RE: Westgate Heights Park Addition, Unit 2 (File: M09D008B)
8810 Sonya Ave. SW
Grading Plan and Drainage Plan
Engineer's Stamp Date – No Stamp

Based upon the information provided in your submittal received 10-15-15, the above referenced Grading Plan and Drainage Plan cannot be approved for Grading Permit and Paving Permit until the following comments are addressed.

OVERALL GRADING AND DRAINAGE PLAN

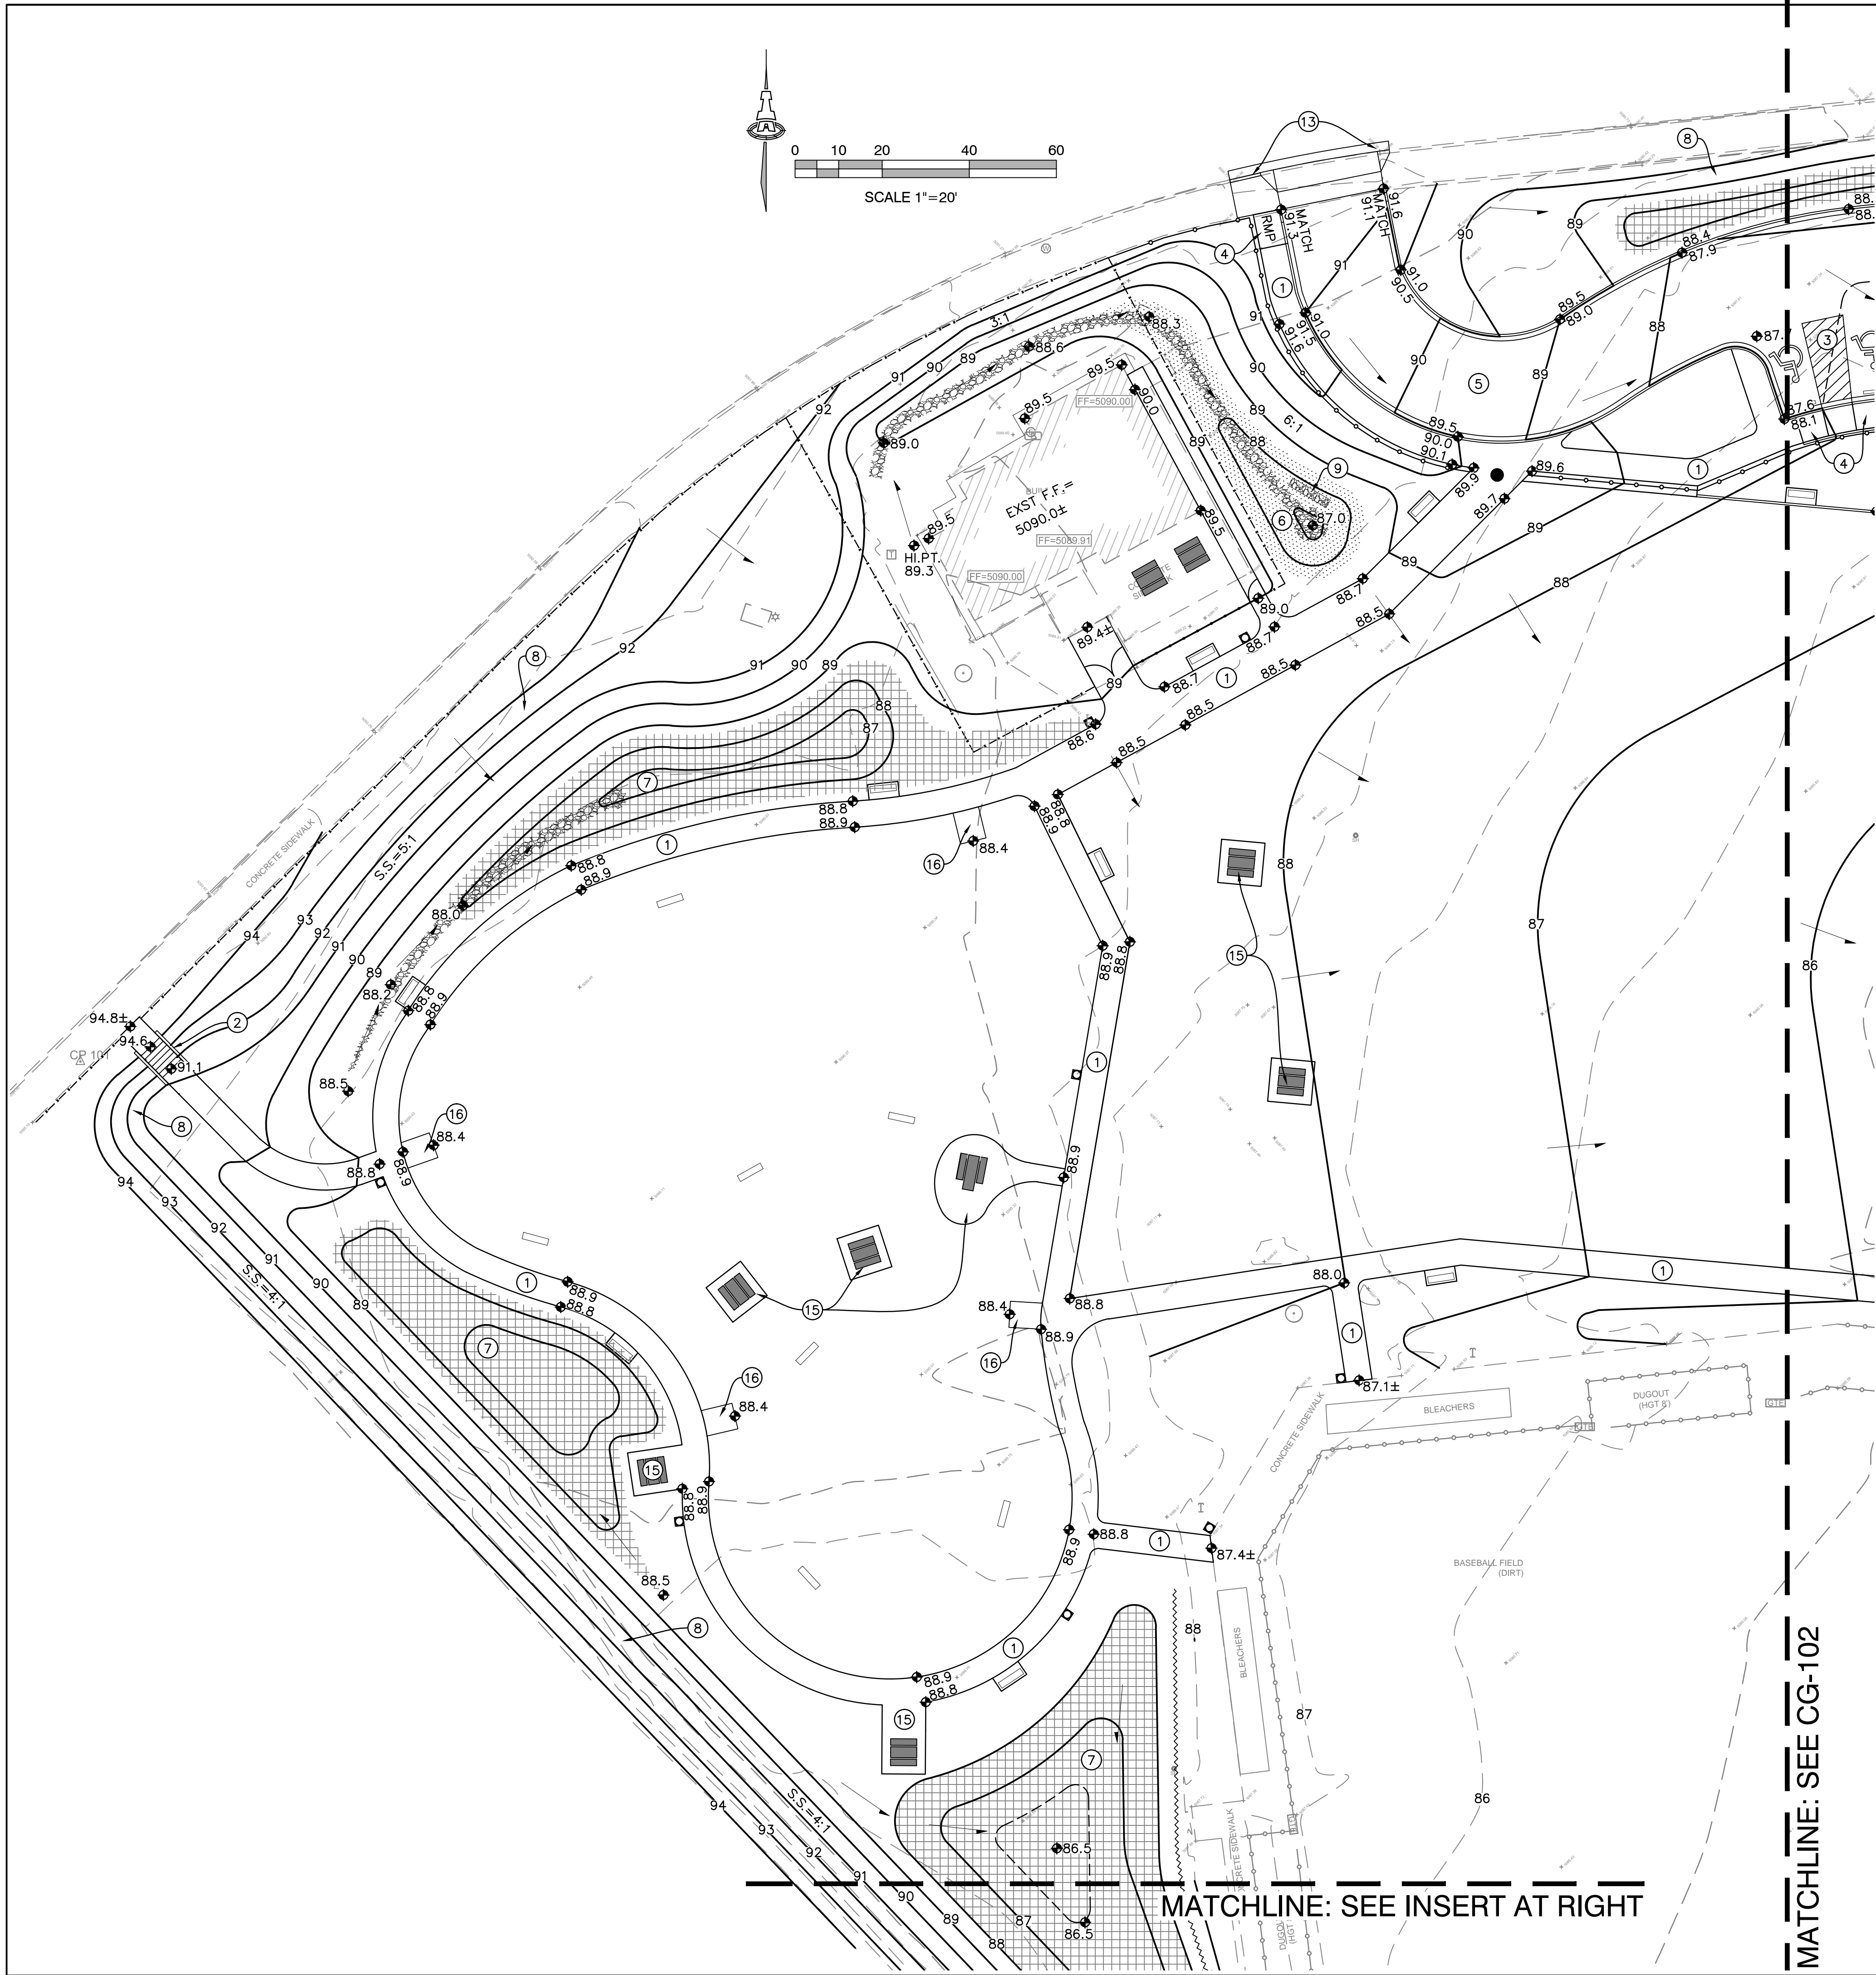
- Delineate drainage basins to clearly identify flow patterns directed to onsite water harvesting ponds. Tabulate basin flows and water harvesting pond volumes.

- Include total discharge to 86th Street through existing sidewalk culvert.
- General Note "Z" on the Grading General Notes and Details sheet states that a SWPPP is not required. The total project area of disturbance appears to exceed 1 acre. Adjust note to include plans for a SWPPP.

- Based on spot elevations shown, the open area at the northwest corner of the project appears to be at the same elevation. Adjust grades in this area to ensure positive drainage is met.

- Provide existing flow line, top of curb and sidewalk elevations at all proposed drivepad and ADA ramp locations.
- The parking area near the intersection of Sonya Ave. and Sapphire Road appears to direct parking lot and field flows to a point location, discharging to the harvesting and first flush ponds. Consider the use of valley gutters in this area to ensure positive drainage is met.

- Specify curb cuts within the parking lot at all point discharge locations to a pond.
- Provide emergency outfall information for all water harvesting and first flush ponds.

- Identify the limits of pavement and sidewalk removal needed for proposed improvements.

WESTGATE HEIGHTS PARK
GRADING GENERAL NOTES AND DETAILS

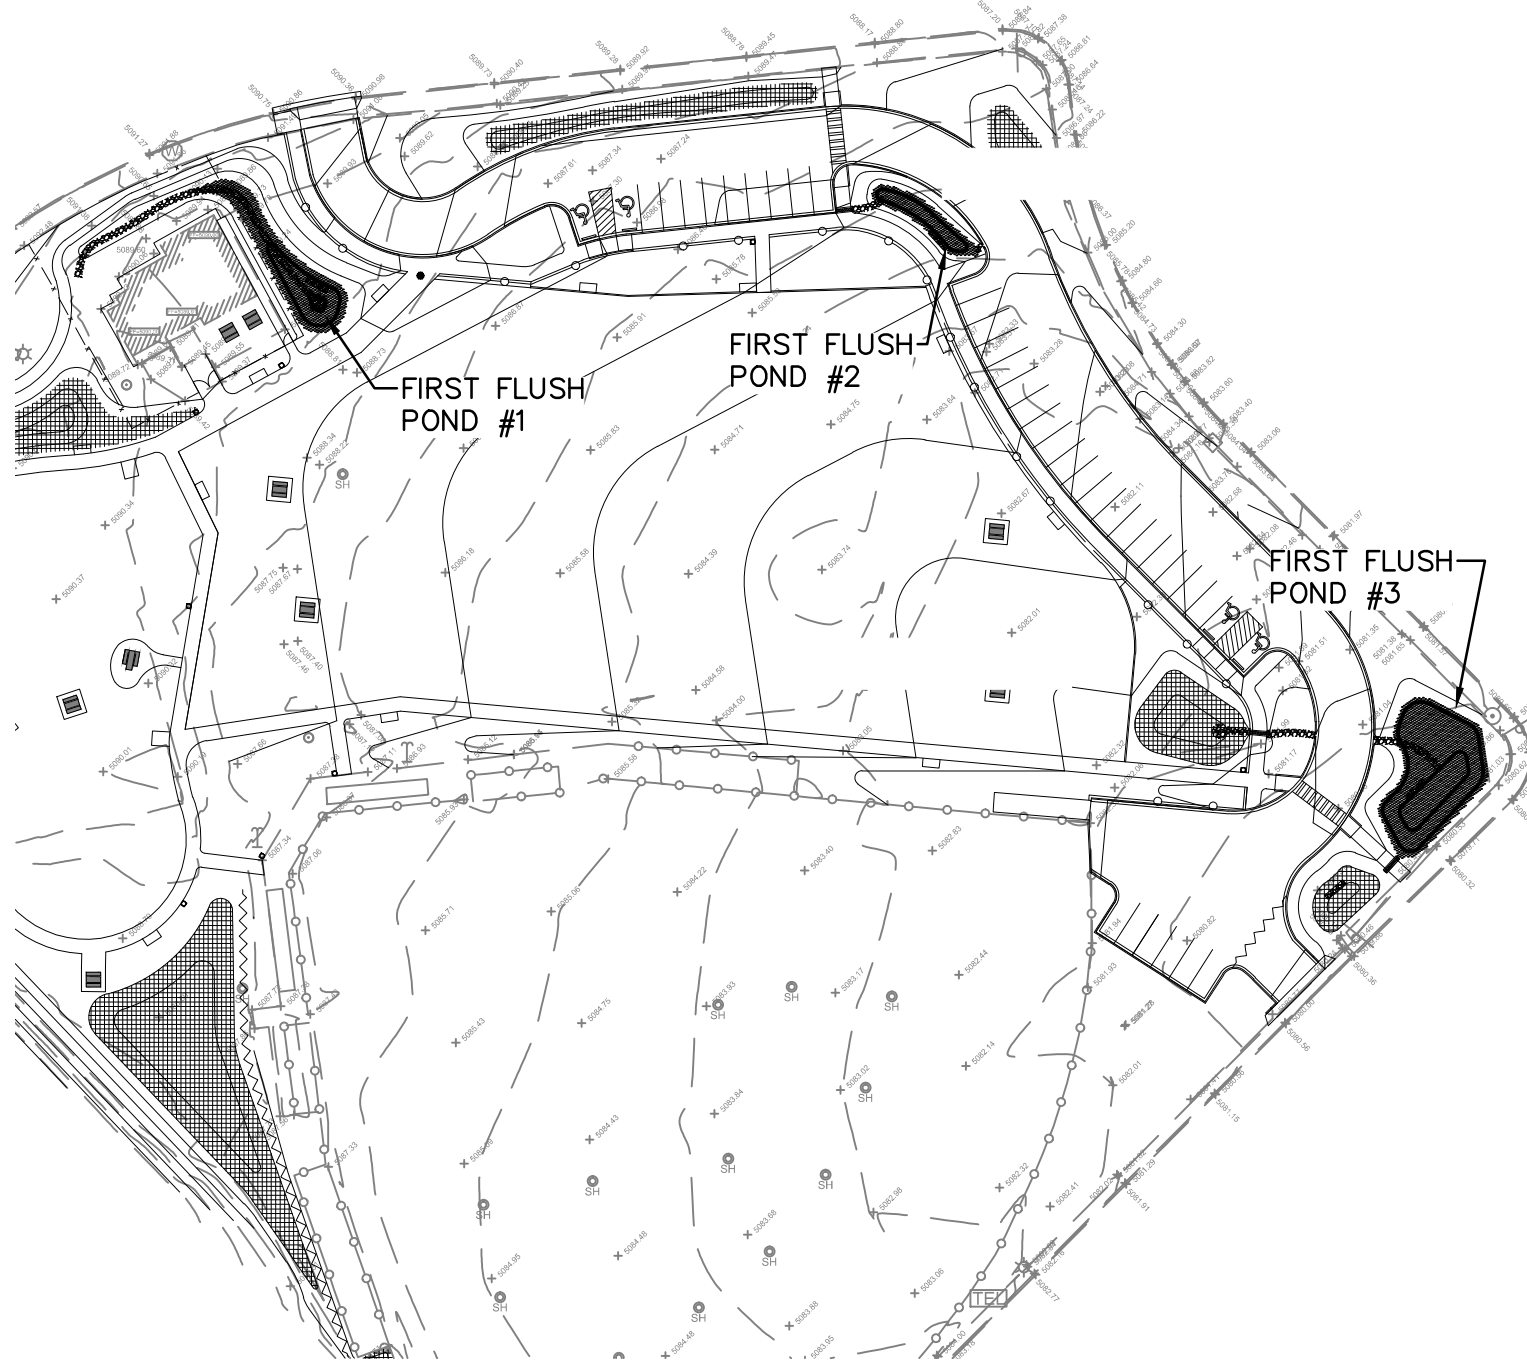
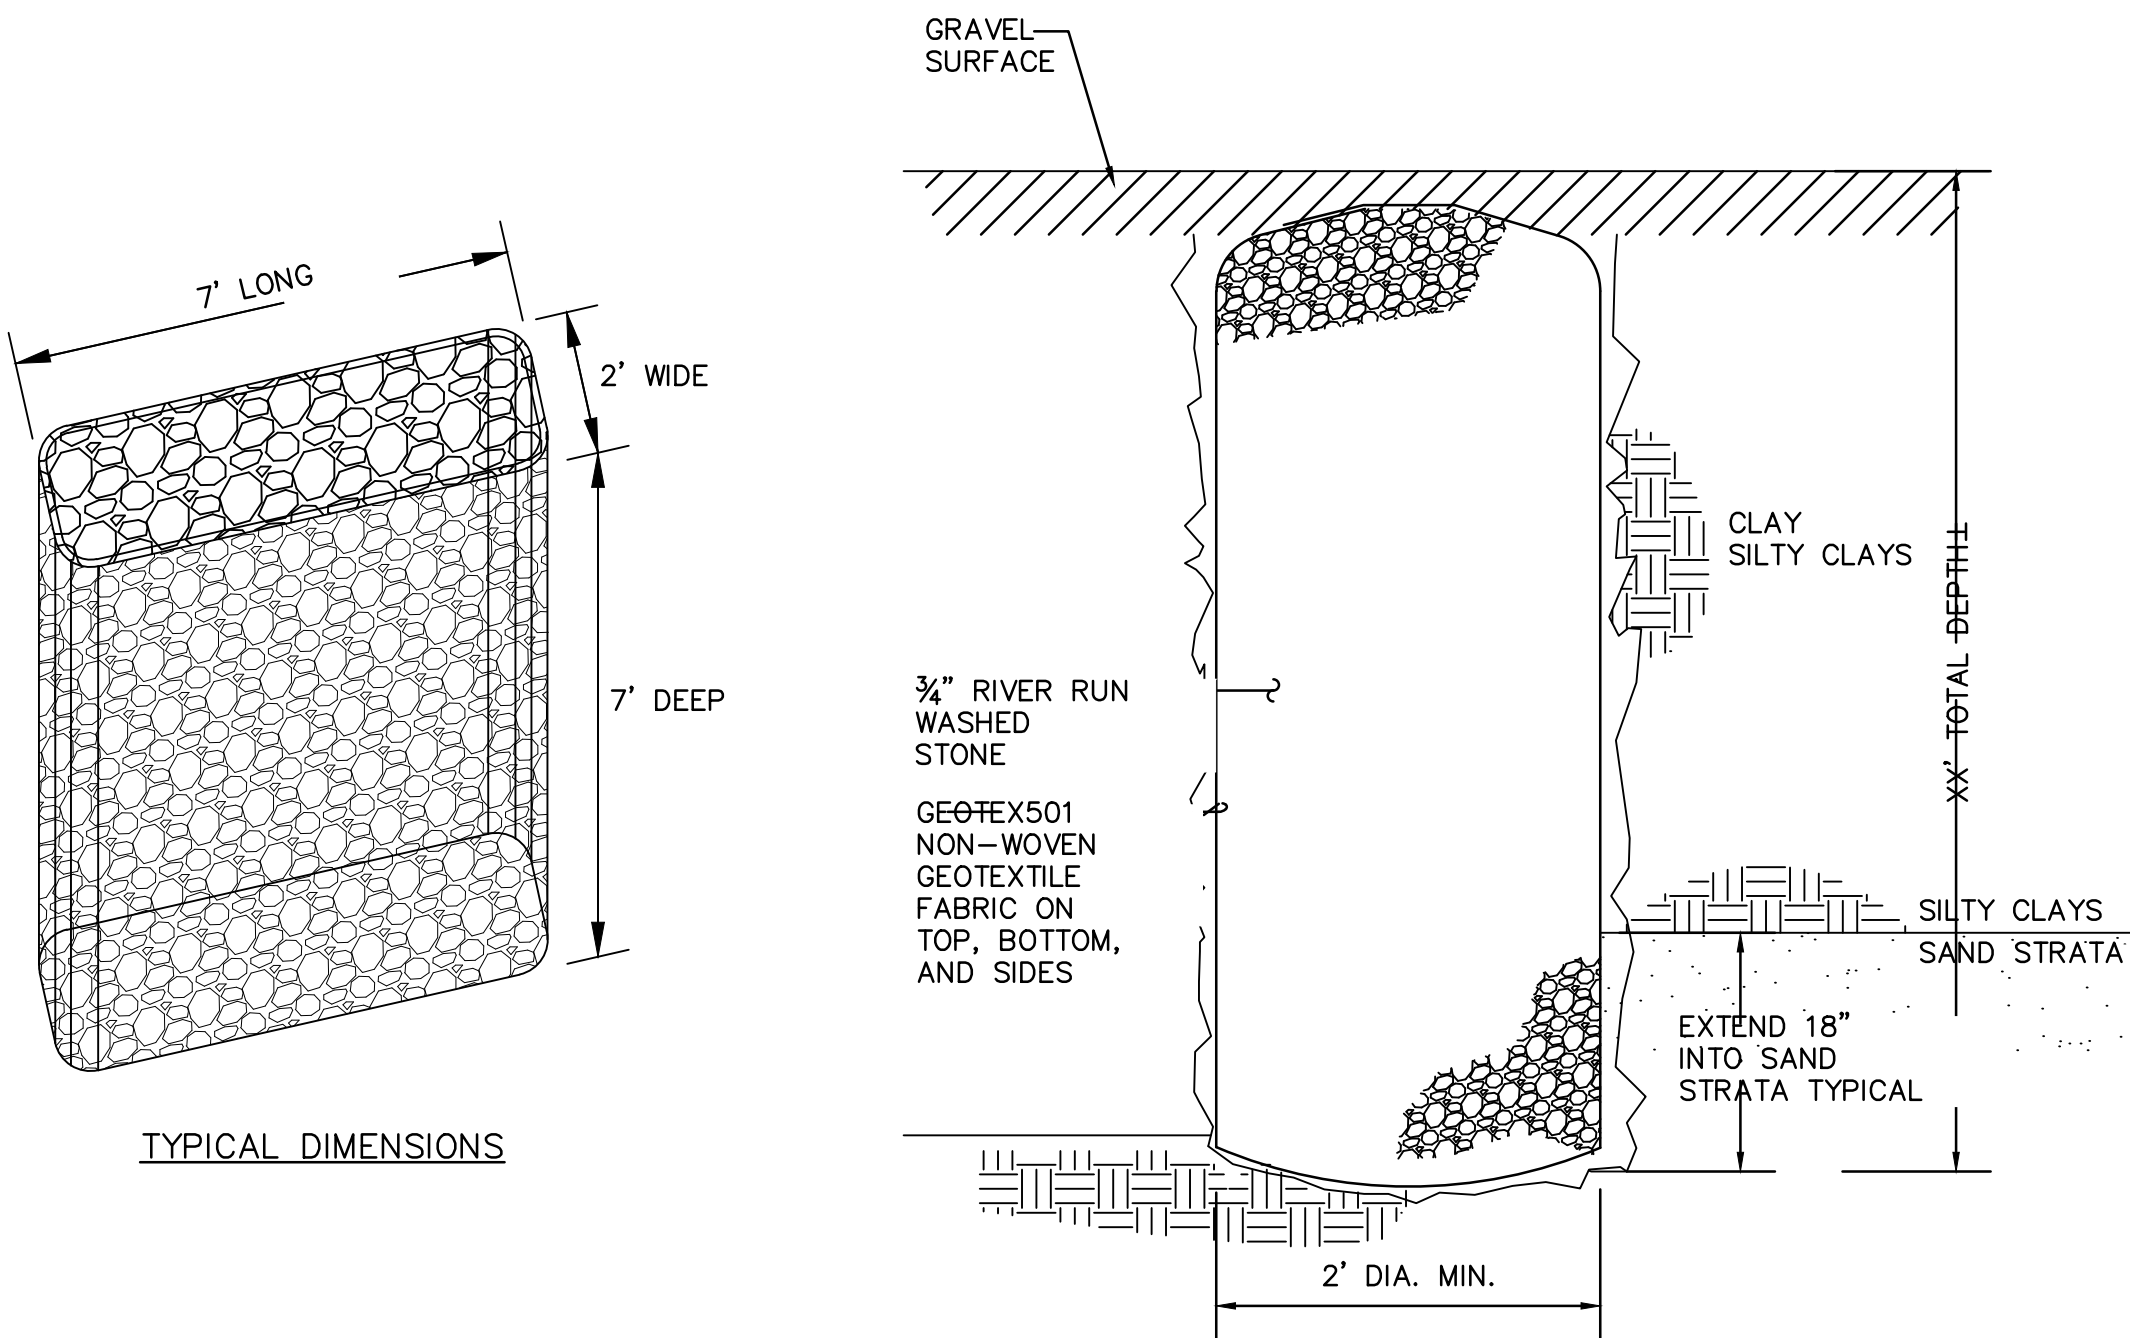
- When specifying the City of Albuquerque sidewalk culvert detail, ensure a supplemental note is provided for the bolts to be tack welded to the plate.
